February 22, 2011

**Re: Comments on the Dominguez Channel and Greater Los Angeles and Long Beach Harbor Waters Toxic Pollutants Total Maximum Daily Loads, Draft**

On behalf of the City of Signal Hill, Flow Science is pleased to provide comments on the "Dominguez Channel and Greater Los Angeles and Long Beach Harbor Waters Toxic Pollutants Total Maximum Daily Loads, Draft" (Draft TMDLs). Throughout this letter, the term "Draft TMDLs" is used to refer to Attachment A to Resolution No. R11-XXX, while the term "Draft Staff Report" is used to refer to the Staff Report accompanying the Draft TMDLs.

**Figure 2. Draft TMDL-allocated (allowable) watershed loading rates for DDT. See Attachment A to these comments for detail.**

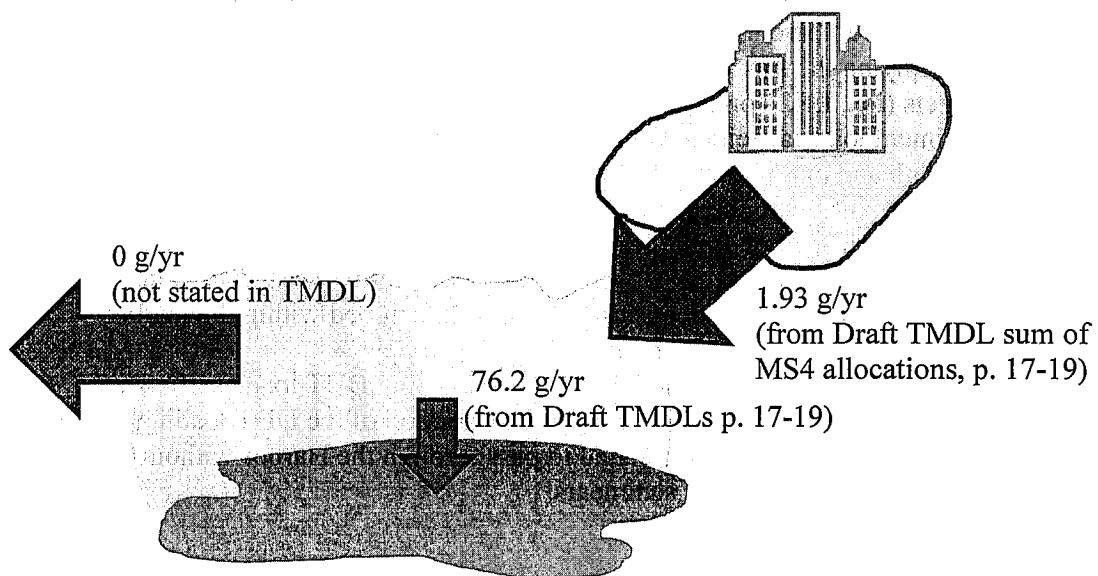
The allowable loads under the Draft TMDLs are shown in **Figure 2**. As can be seen by comparing **Figures 1** and **2** and reviewing **Table 1**, the Draft TMDLs require that loads of DDT from the watershed be reduced by 99.91% to 99.991%. Similarly large load reductions are also required for other pollutants, as shown in **Table 1**.

**Figure A-2. SQO Assessment Results within Los Angeles and Long Beach Harbors. Reproduced from Figure C-3 of SCCWRP (2008).**

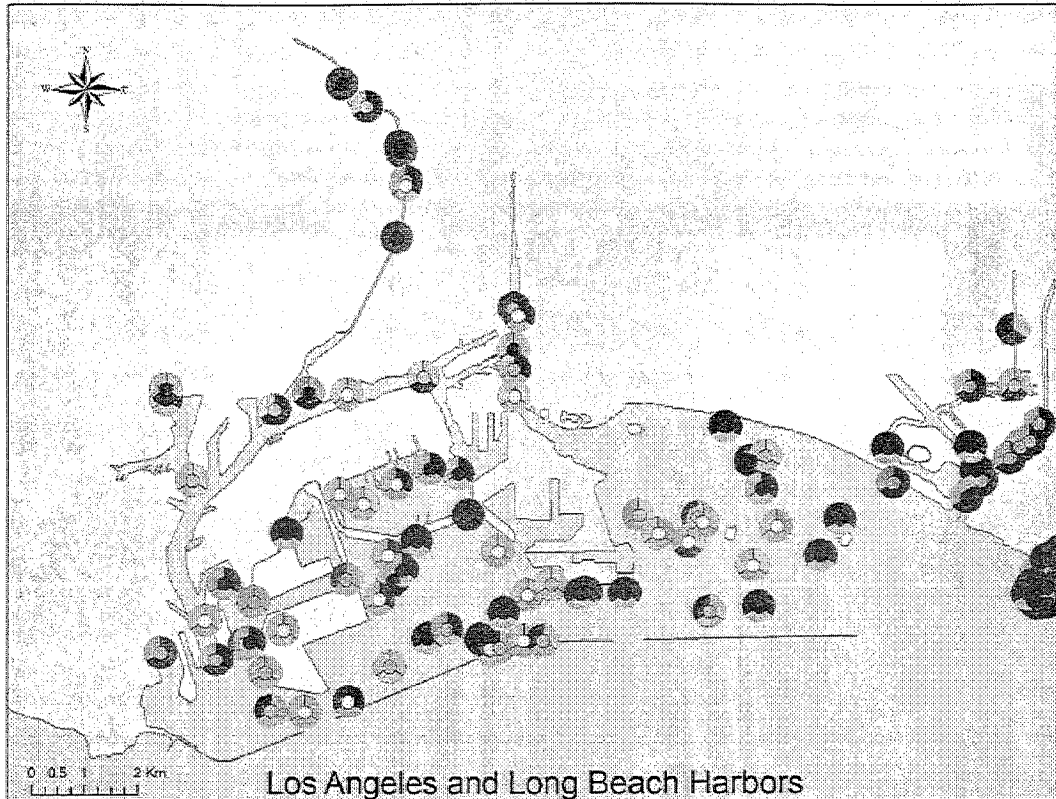
The impact of using SQGs as Draft TMDL targets can be seen by comparing assessment results under the SQO Policy with an assessment made using the Draft TMDL targets. **Figures A-1 and A-2** reproduce maps of SQO results produced by SCCWRP during SQO development (SCCWRP, 2008)<sup>3</sup>. These figures show that 35% of stations (26 of 75 stations) are classified as “unimpacted” and 17% are classified as “likely unimpacted” (dark and light green, respectively). An additional 31% are classified as “possibly impacted,” which is defined in the SQO Policy to mean that “Contamination at the site may be causing adverse impacts to aquatic life in the sediment, but the level of impact is either small or is uncertain because of disagreement among LOEs [lines of evidence].” Only 13 stations (17%) are classified as “likely impacted” (orange) or “clearly impacted” (red).

**Figure A-8. Left two panels: Modeled and observed DDT and PCBs concentrations for the Forest Subwatershed. Right two panels: Modeled and Observed DDT and PCBs concentrations for the Pier A subwatershed.**

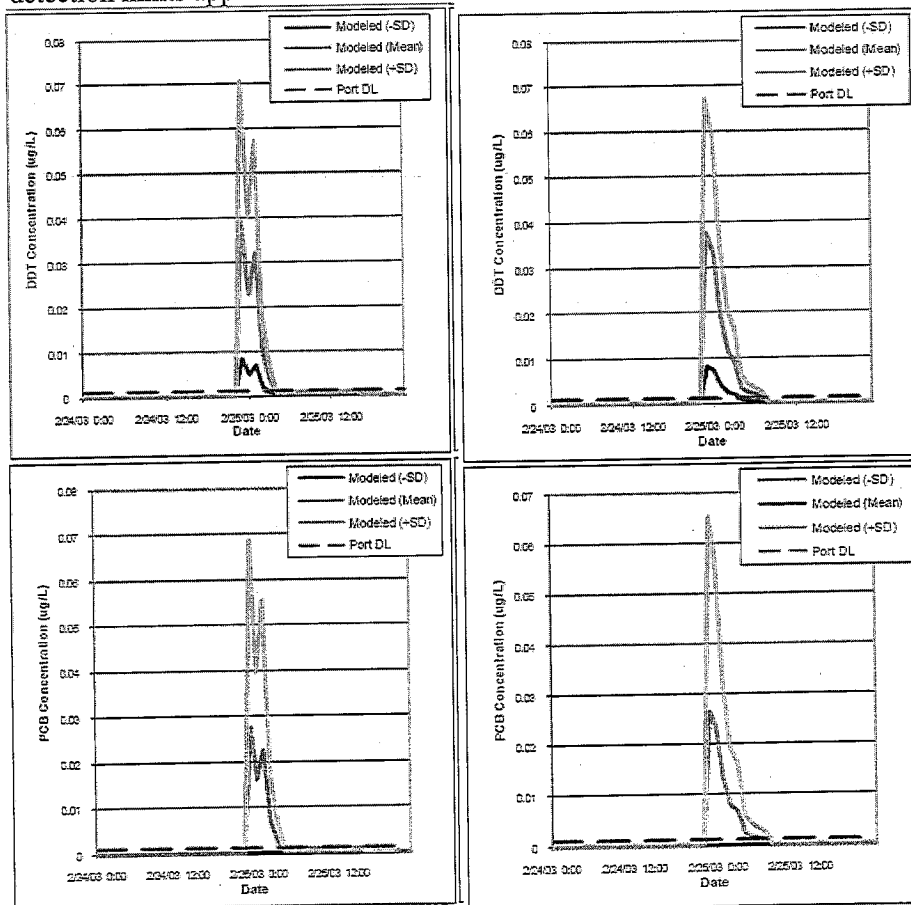
Of most concern, however, is that this method of estimating pollutant loads from the watersheds does not appear to yield realistic results. As shown in **Figure A-8** below for DDT and PCBs (reproduced from Figures 24 and 25 of Appendix II to

Reproduced from Figures 24 and 25 of Appendix II to the Draft Staff Report. Note that detection limits appear to be far lower than the modeled DDT and PCB concentrations.

**Figure A-9. Modeled and Observed TSS for the Pier A Subwatershed.  
Reproduced from Figure 8 of Appendix II of the Draft Staff Report.**

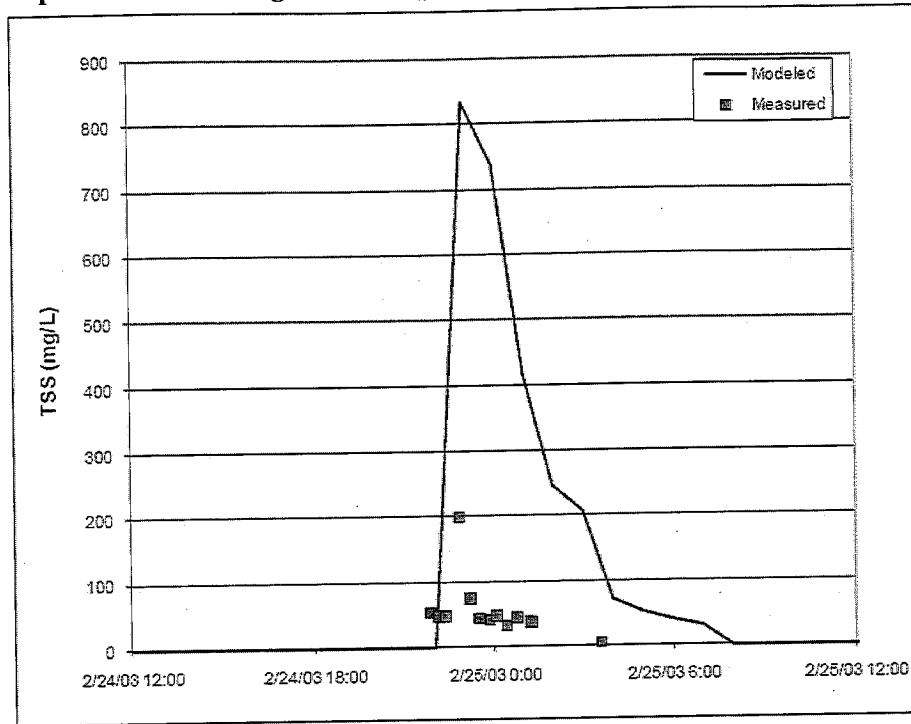
The results indicate that model predictions only marginally resemble the observations for the single storm event used in the analysis (e.g., see Appendix II, Figures 5-9, pg. 16-21). Model performance during the calibration and validation phases was largely assessed qualitatively, using visual comparisons of the model predictions and observations. **Figure A-9** provides an example plot, reproduced from Appendix II of the Draft Staff Report, showing that the model appears to overestimate TSS concentrations in runoff from the Pier A subwatershed quite dramatically.

Figure 6-3. Measured *E. coli* Concentrations along the LA River

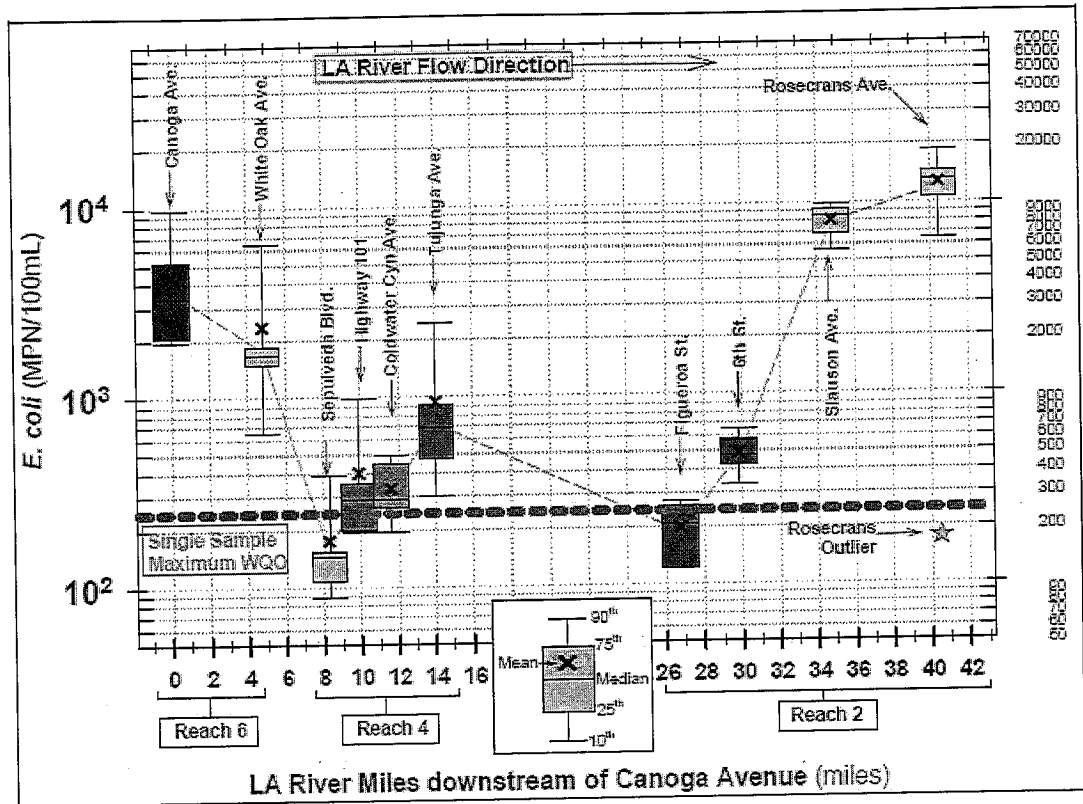
Additional information is provided by reviewing **Figures 6-3 and 6-12** of the CREST report (at p. 6-11 and 6-25, respectively, and reproduced below), which show measured concentrations of *E. coli* and human bacteroidales from six dry weather sampling events along the length of the river. As shown in **Figure 6-3**, concentrations of *E. coli* fall to levels mostly below water quality objectives for *E. coli* downstream of sewage treatment plants. Highly purified wastewater enters the Los Angeles River between river miles 5 and 8, and between river miles 14 and 26. However, downstream of those locations, *E. coli* concentrations rise again. Note in particular the rise in *E. coli* concentrations between 6<sup>th</sup> St. and Slauson Ave.

Figure 6-12. Measured Human-specific *Bacteroidales* Concentrations along the LA River

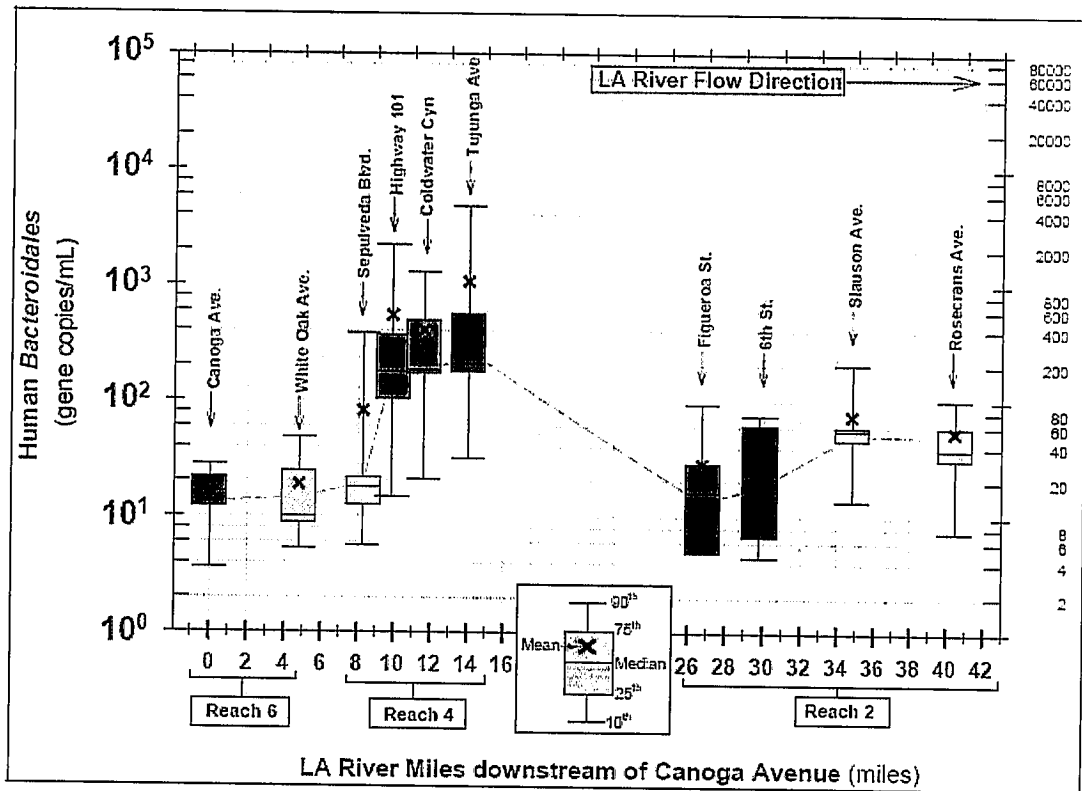
**Figure 6-12** presents concentrations of human bacteroidales, measured in the same samples from which the *E. coli* measurements (shown in **Figure 6-3**) were obtained. Note the concentrations of human bacteroidales increase only slightly in Reach 2 of the river between 6<sup>th</sup> Street and Slauson Ave. The increase in *E. coli* concentrations in this river segment is far greater (more than one order of magnitude) than the corresponding increase in bacteroidales, indicating that the *E. coli* in this segment is from non-human

sources. These data indicate that non-human sources (which may include wildlife and birds, or regrowth in sediments) are likely responsible for the exceedances of water quality criteria in this river segment.

**Figure 6.** DDT concentrations in red shiner collected from San Diego Creek (Source: Stakeholder presentation at April 7, 2009, Panel meeting).

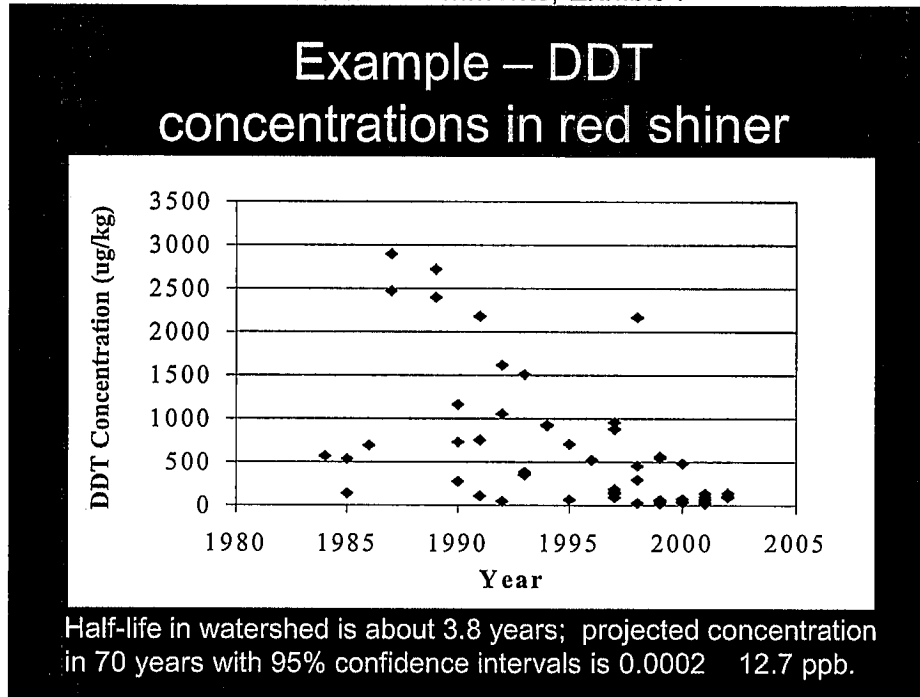
1. Board staff should examine available trend data to determine if they can be interpreted equally well from different perspectives. For example, Figure 6 (taken from the stakeholders' presentation) suggests event-related increases in DDT levels in the late 1980s and again in the late 1990s. These could be associated with periodic increased loads from agricultural lands associated with stormwater or other disturbances, such as construction and changes in land use. Comparison with rainfall and sediment loading records would be useful in testing these possibilities. Such information would provide important insights that are missed by making simplifying assumptions about decay rates.
